Subject: LaSalle County Nuclear Power Station Units 1 and 2
Submittal of Additional Information discussed during
Conference Calls Regarding Modifying the Main Steamline
Tunnel Automatic Isolations
NRC Docket Nos. 50-373 and 50-374

Attachment A

Attachment B

Attachment 2
Upper MST Temperature
following loss of VR on
8/25/95
(95°F inlet)

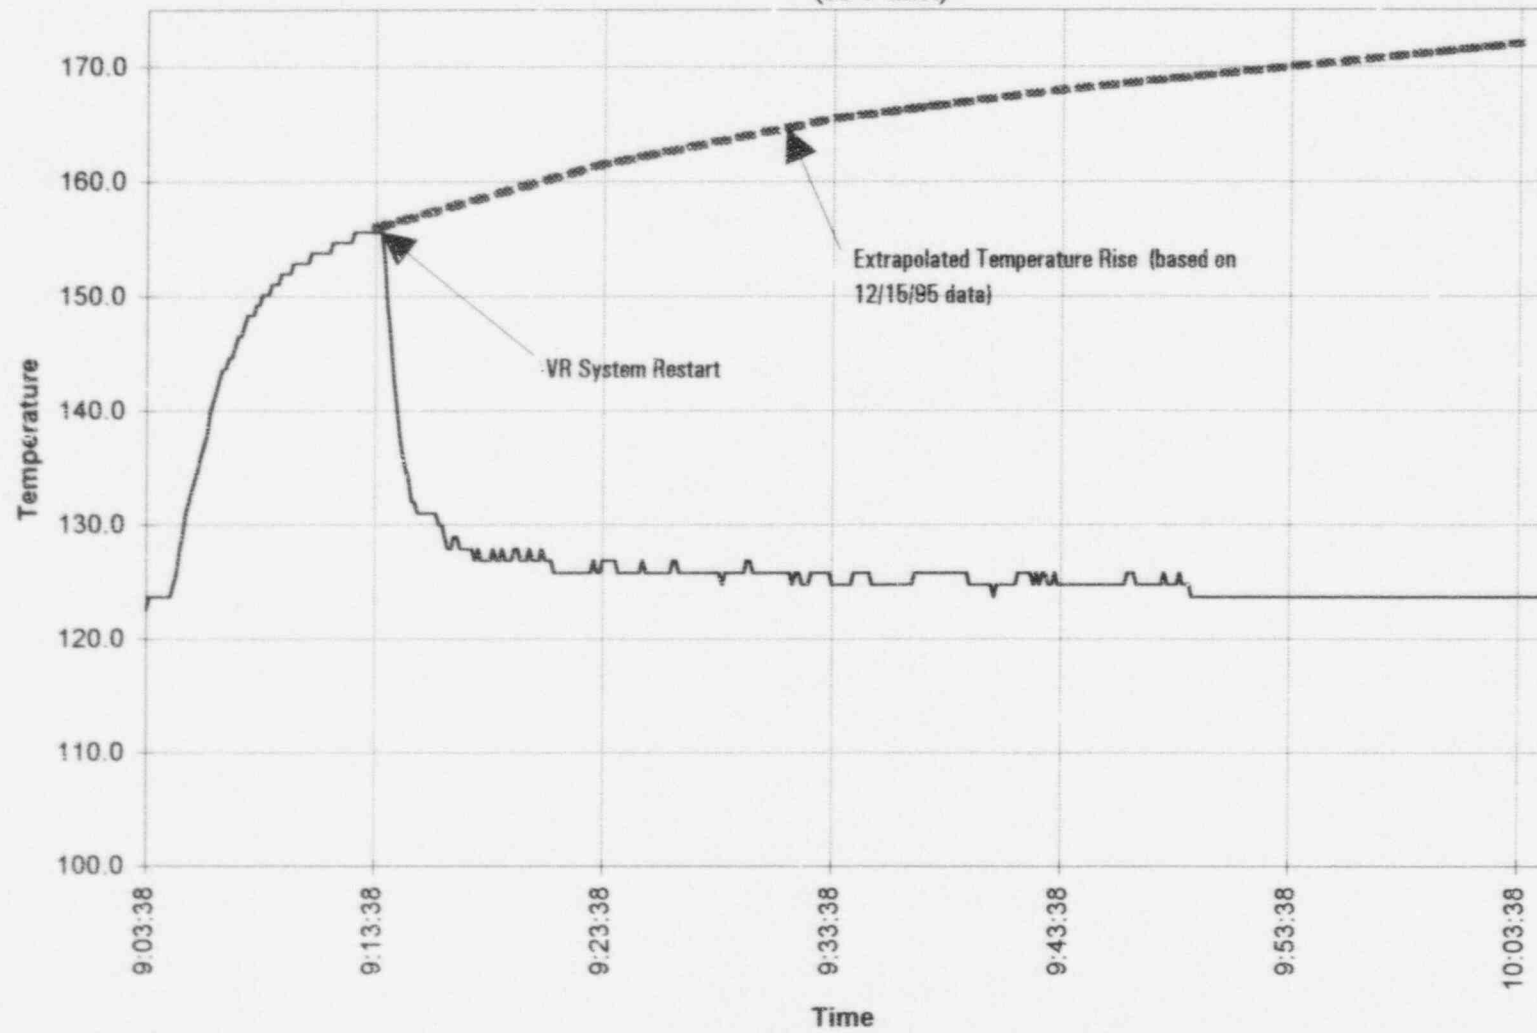
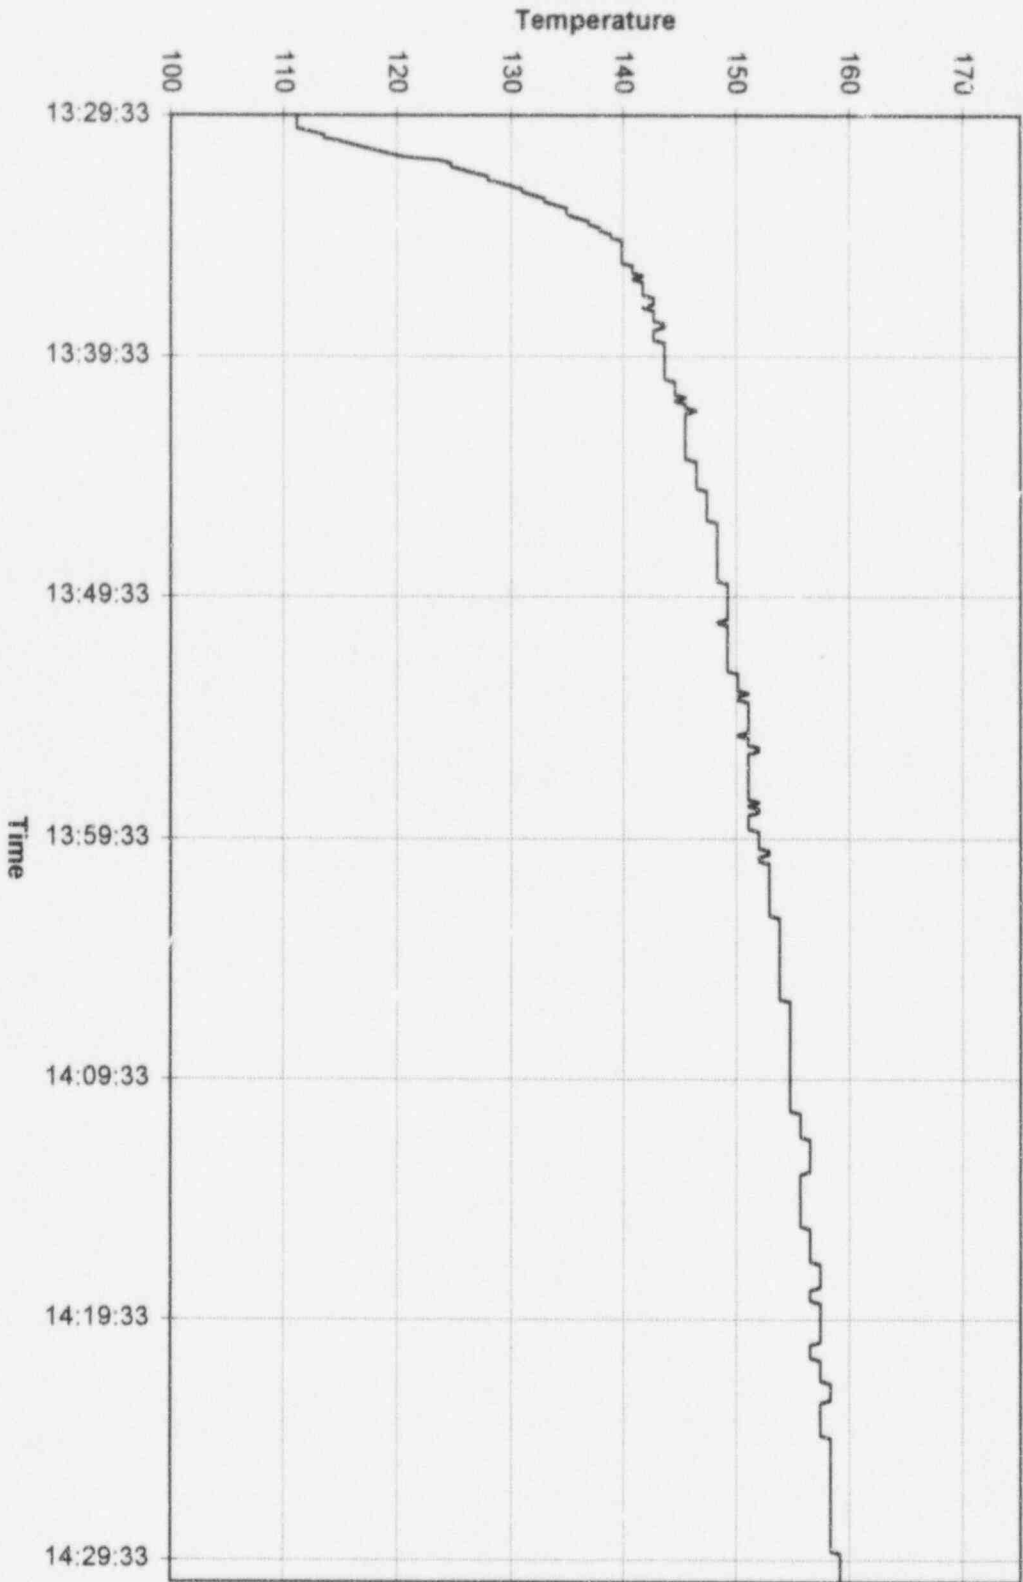
Describe the 8/25/95 and 12/15/95 events.

How was the data from the 8/25/95 event extrapolated?

- Winter Condition Setting
A winter setting would be based on a 100 gpm leak, 151°F (Attachment 1) minus 15°F (instrument error band) for a 136°F setpoint. If VR is lost (assuming no leakage) a 136°F setpoint is reached in about 2½ minutes (Attachment 2) on a summer day (95°F inlet temperature.) On a winter day (81°F

Attachment 2 and 3 indicate the upper MST temperature response following a loss of VR for the subject dates. VR was manually secured on both of these dates for planned surveillance testing. The data was collected for use on this project.

The 8/25/95 data was extrapolated following VR system restart by projecting the response curve from the 12/15/95 event onto the 8/25/95 data curve. This extrapolation should be reasonable for estimating required operator response times. Note that the shape of the 8/25/95 curve and the 12/15/95 curves are identical from the time of initiation until the 8/25/95 event was terminated at the 10 minute mark. The only difference between the two curves is that the 8/25/95 curve is raised by 14°F which corresponds to the difference in VR inlet temperature on those two days.

Figure 5: Upper MST Temperature due to Steam Leakage

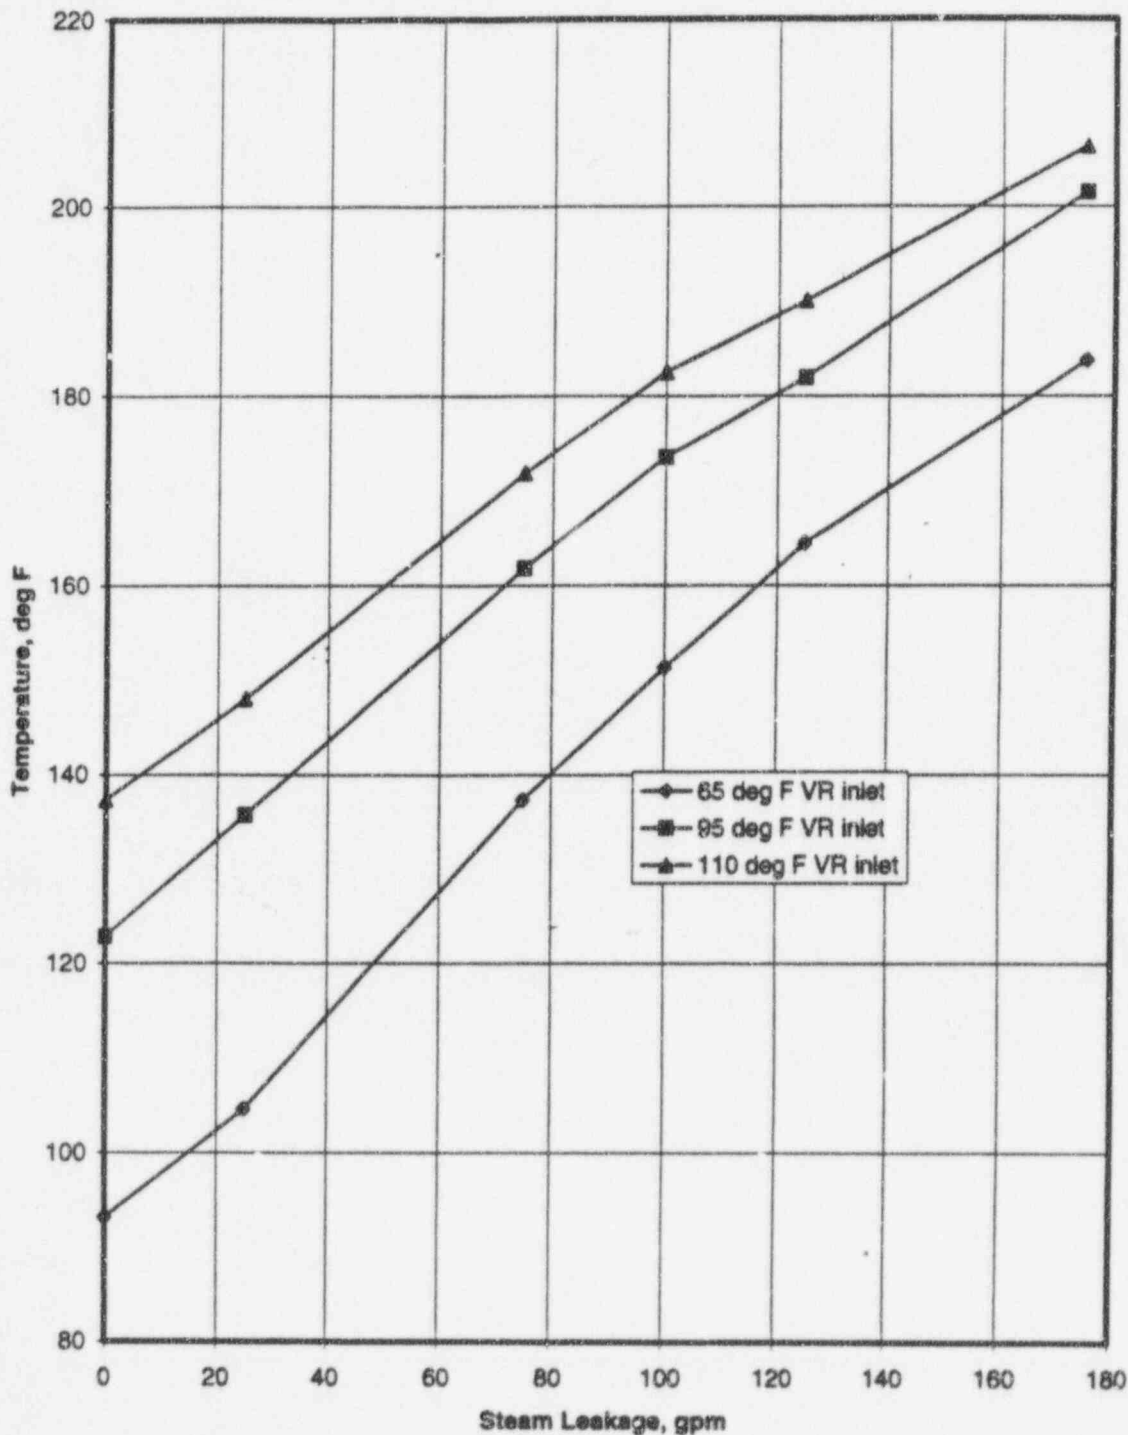
During the 3/14/96 Telecon with the NRC, ComEd was asked to address two areas of concern. (1) Is it possible to keep the high temperature automatic isolation function, based on the 100 gpm leak value, without requiring heroic operator actions on loss of Reactor Building Ventilation (VR), to prevent a Group 1 Main Steam Line Isolation and unit SCRAM? (2) Will the changed Technical Specification values jeopardize the environmental qualification of any equipment in the MST?

We also considered a setpoint based on ensuring the operators have a minimum of 30 minutes before taking required action after a loss of VR. This setpoint would start with 166°F (from Attachment 2) add 15°F for the instrument error band and add another 15°F for the 110°F design inlet condition. This would give a setpoint of 196°F. During the winter design conditions no isolation would occur until the leak was greater than 200 gpm (Attachment 4 extrapolation). Again, this would not be conservative with respect to the 100 gpm criterion.
